**Final Drainage Report  
The Glen at Widefield Filing No. 9  
El Paso County, Colorado**

Kiowa Project No. 17038

December 15, 2017

**Stage-Storage Calculation**

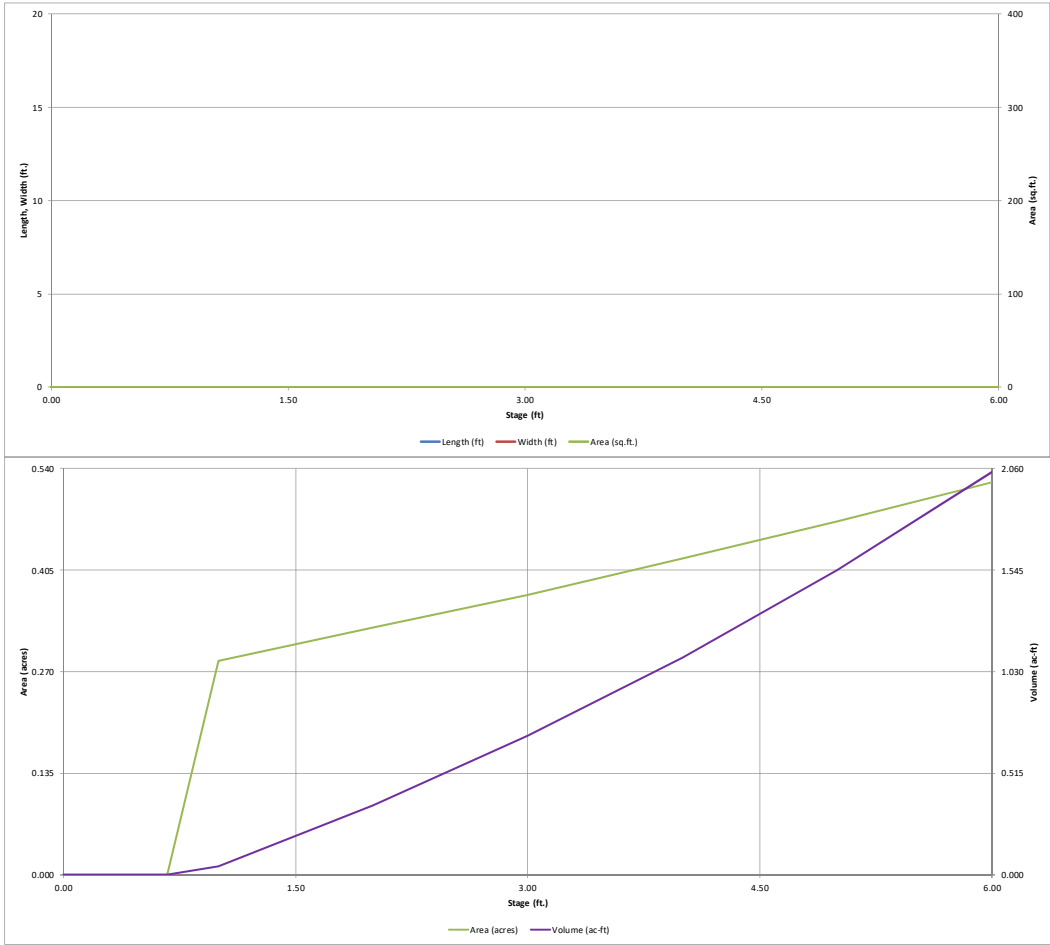
Revise. The 0.25 ac-ft is the volume for Zone 2 (EURV minus WQCV) but the required total EURV volume itself is 0.45 ac-ft.

This value is low. A 32.7% impervious roughly equates to a 13.5ksf lot sizes. Looking at the plat & GEC plan, the majority of the lot sizes draining into the pond are between 6ksf to 7.5ksf.

**GLEN AT WIDEFIELD EAST  
DRAINAGE PLAN  
EXISTING CONDITION  
EL PASO COUNTY, COLORADO**

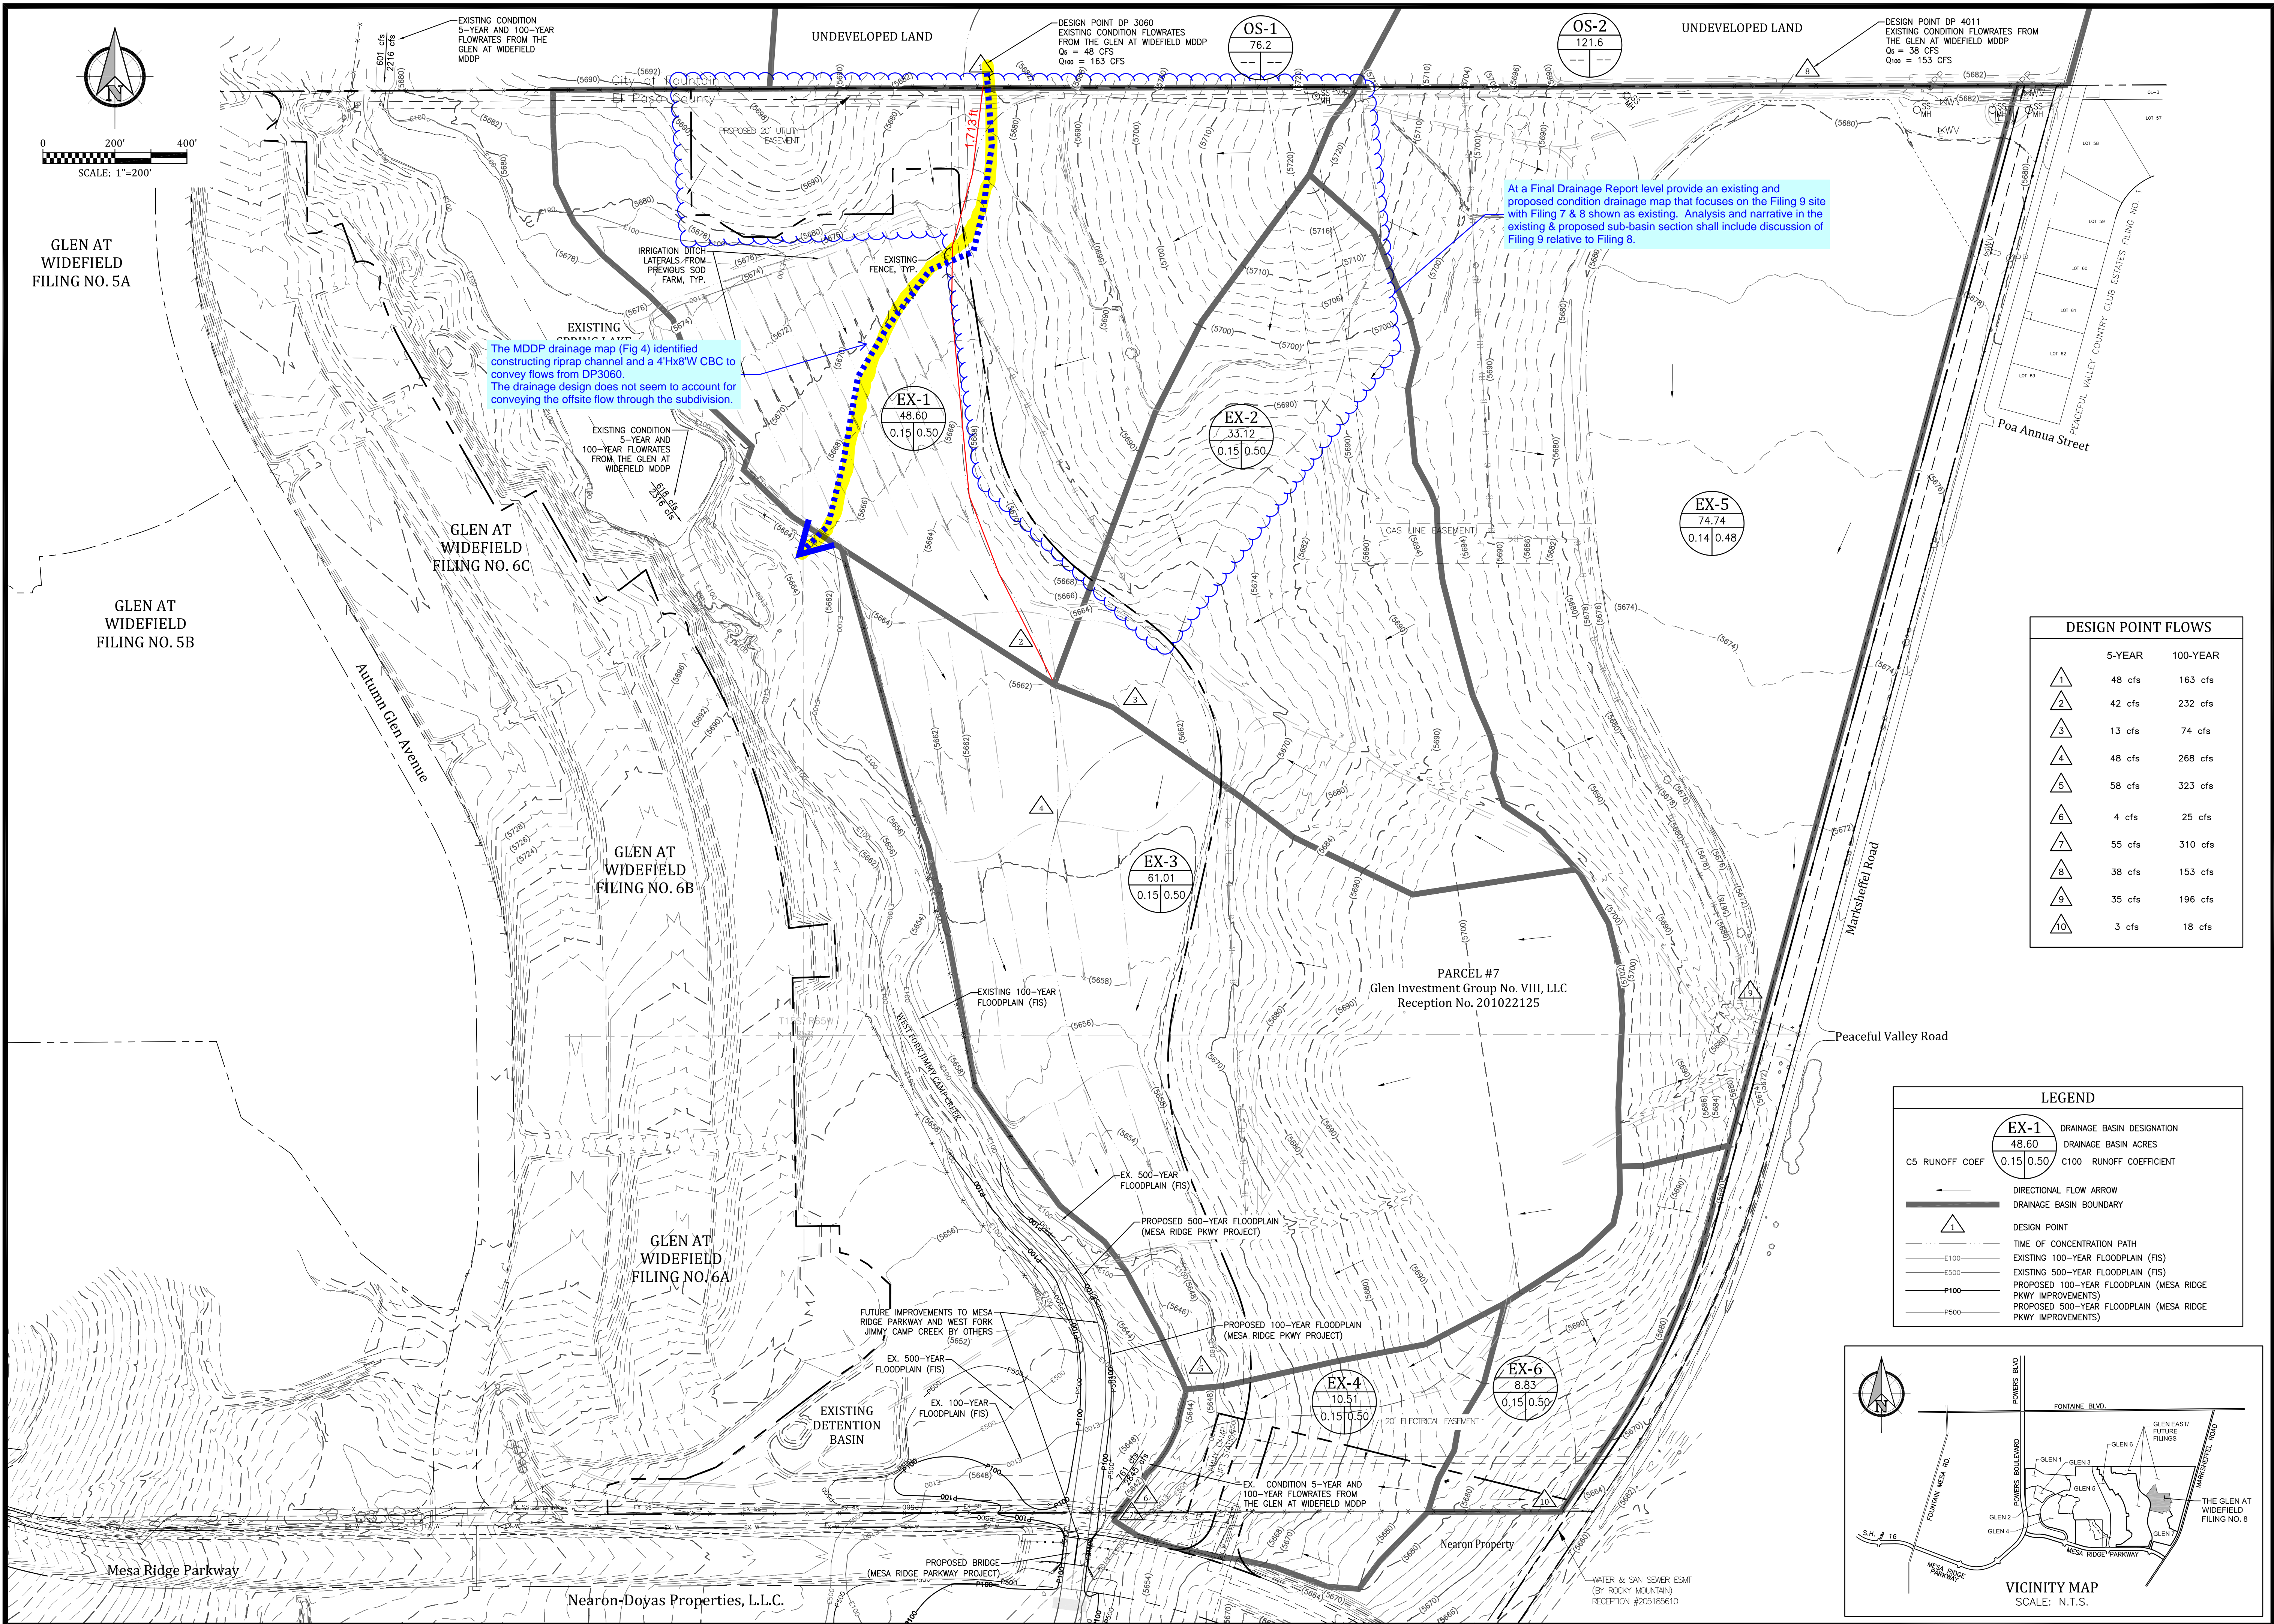
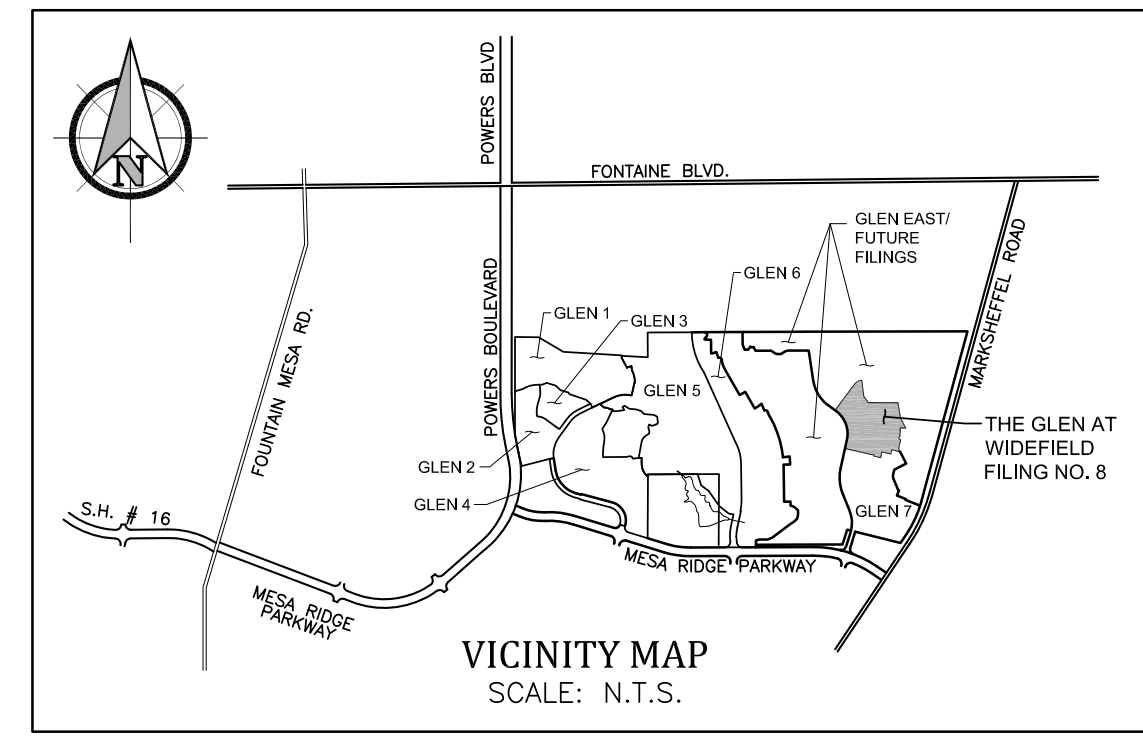
Show the 48" RCP & provide a callout label on the drainage map

Sheet 2 is missing

At a Final Drainage Report level provide an existing and proposed condition drainage map that focuses on the Filing 9 site with Filing 7 & 8 shown as existing. Analysis and narrative in the existing & proposed sub-basin section shall include discussion of Filing 9 relative to Filing 8.
